No. 0384-24I, Rev. I
ATA Code 75-40

SUBJECT: POWER PLANT – MANIFOLD PRESSURE LINE MODIFICATION

SYNOPSIS OF CHANGES: Service Instructions reprinted in ATA format and reissued to supersede and cancel the original issue of these Service Instructions. The manifold hose assembly is replaced with a new hose assembly instead of the tube assembly specified on the original issue. Additional aircraft serials added to the EFFECTIVITY.

Manifold Pressure Line Modification.

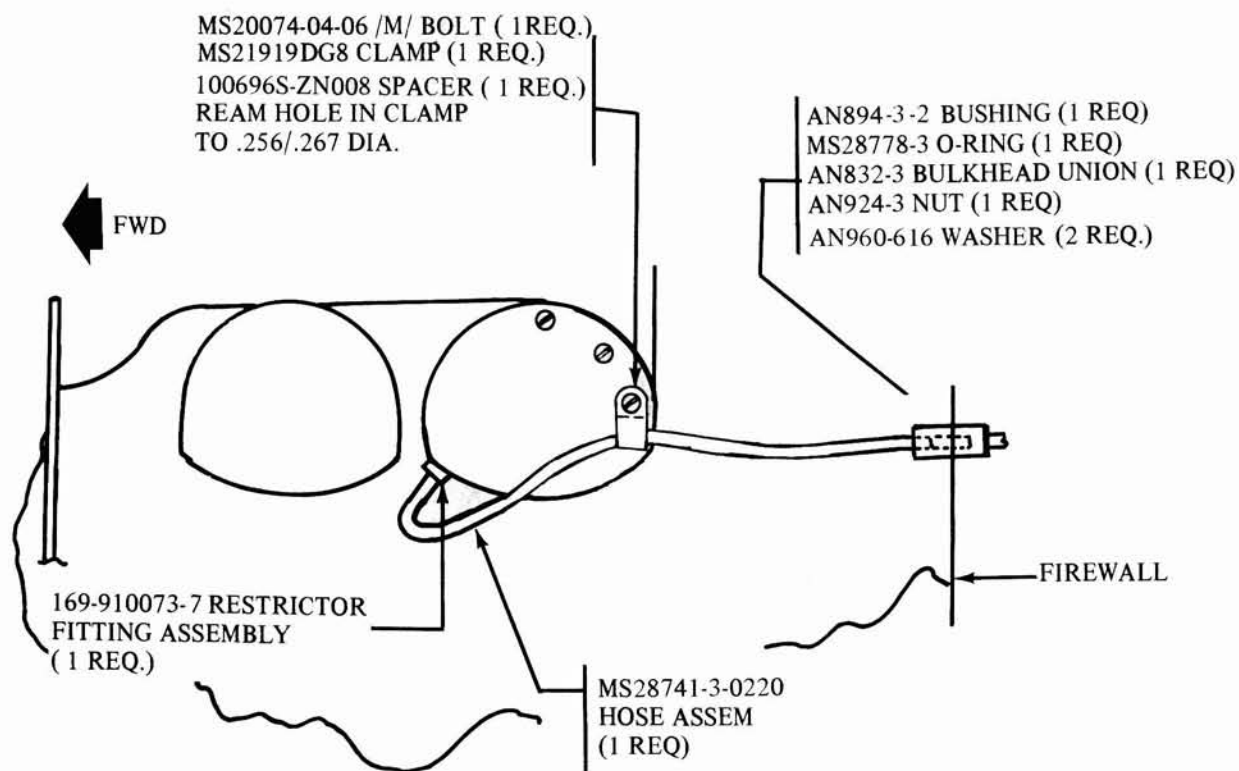
DESCRIPTION: The existing manifold pressure line is to be removed and discarded and replaced with a new hose assembly. Aircraft on which the P/N 169-910017-29 tube has been installed per the original issue of these Service Instructions must be modified by removing and discarding the tube and replacing it with the new hose assembly specified in these Service Instructions.

6. Install new, one each, AN832-3 bulkhead union, AN924-3 nut and two AN960-616 washers in the .44-inch diameter hole which was drilled in step 5. (See illustration.)

9. Install the new MS28741-3-0220 hose assembly between the fitting on the aft left engine cylinder and the firewall fitting per the illustration. Torque these fittings to 70 to 100 inch-pounds.

10. Ream the attaching hole in an MS21919DG8 clamp to .256/.267 inch diameter.
11. Remove the existing aft left cylinder rocker arm cover screw as shown in the illustration and install the clamp on the rocker arm cover with a 100696S-ZN008 spacer and an MS20074-04-06 /M/ bolt. Torque this bolt to 50 to 70 inch-pounds.
